1 Amendments to the Drawings:

1       **REMARKS:**

Fig. 2

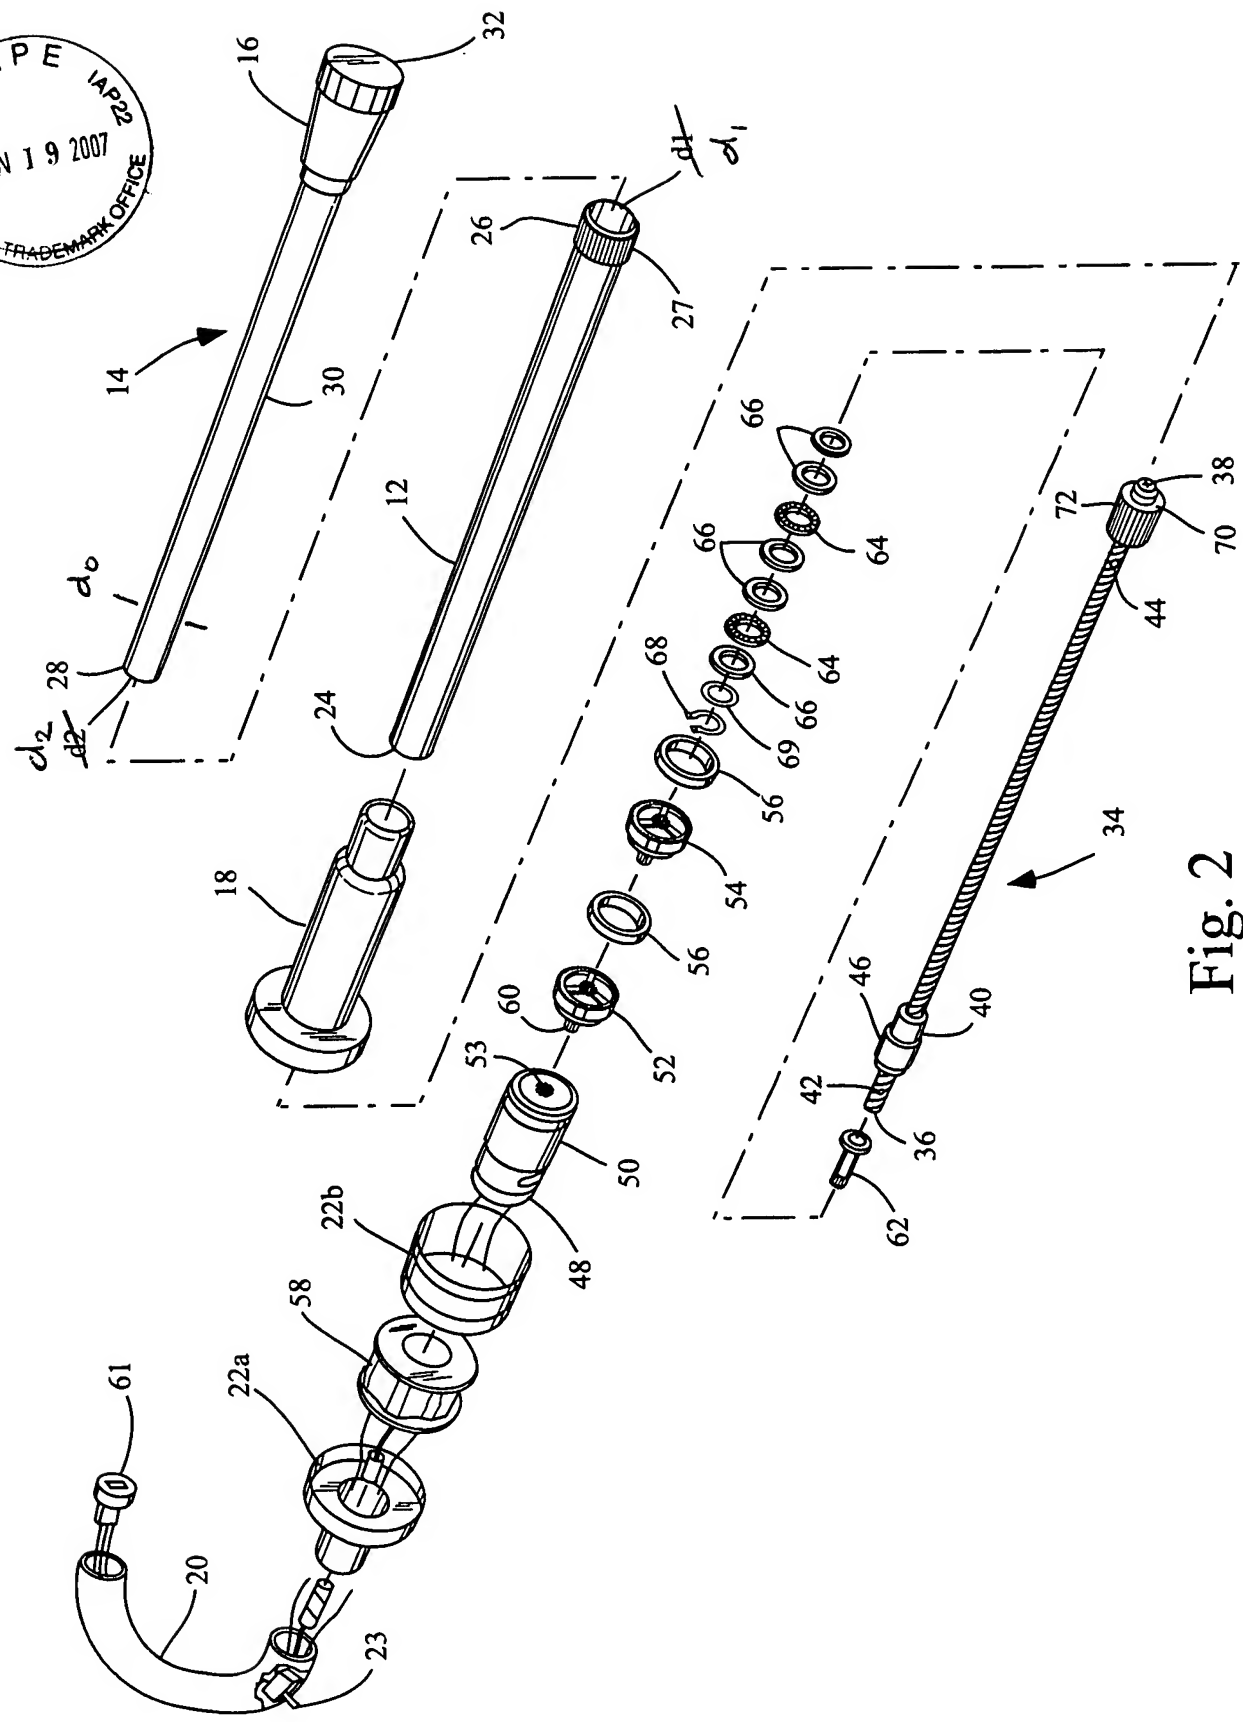
13              The Examiner objected to the drawings because they did not include a reference symbol  
14 for outside diameter  $d_o$  which is mentioned in the description. A replacement sheet for Figure 2  
15 is submitted herewith which shows outside diameter  $d_o$ . In addition, reference numbers  
16 originally indicated as  $d_1$  and  $d_2$  have been respectively changed to  $d_1$  and  $d_2$  to be consistent  
17 with the description.

2           Corrections have been made to Figures 2-3 as required by the Examiner. Figure 2 has  
3 been corrected to add the reference d<sub>0</sub>. Figure 3 has been corrected to delete reference characters  
4 12', 14', 16' and 18' which are not mentioned in the description. It should be noted that although  
5 the Examiner objected to the inclusion of reference character 10' on the grounds it did not appear  
6 in the description, Applicant directs the Examiner's attention to page 2, line 17 of the description  
7 which states "Figure 3 shows an embodiment 10' . . ." Replacement sheets are enclosed for  
8 Figures 2 and 3, as well as annotated sheets for Figures 2 and 3 showing the corrections.  
9  
10  
11  
12  
13  
14  
15  
16  
17  
18  
19  
20  
21  
22  
23  
24  
25  
26

Fig. 3

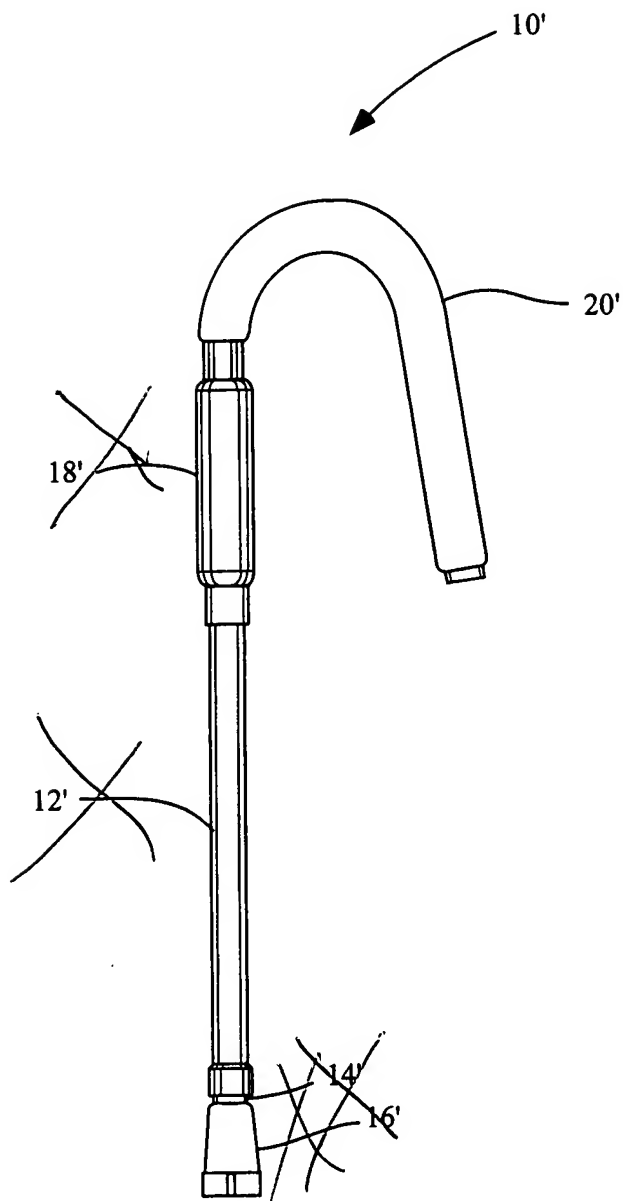
18              The Examiner objected to the drawings on the grounds that the drawings, specifically  
19 Figure 3, included the following reference characters not mentioned in the description: 10', 12',  
20 14', 16' and 18'. It should be noted that although the Examiner also objected to the inclusion of  
21 reference character 10' on the grounds it did not appear in the description. However, page 2, line  
22 17 of the description states “Figure 3 shows an embodiment 10' . . .” Reference character 10'  
23 has therefore been left on Figure 3.
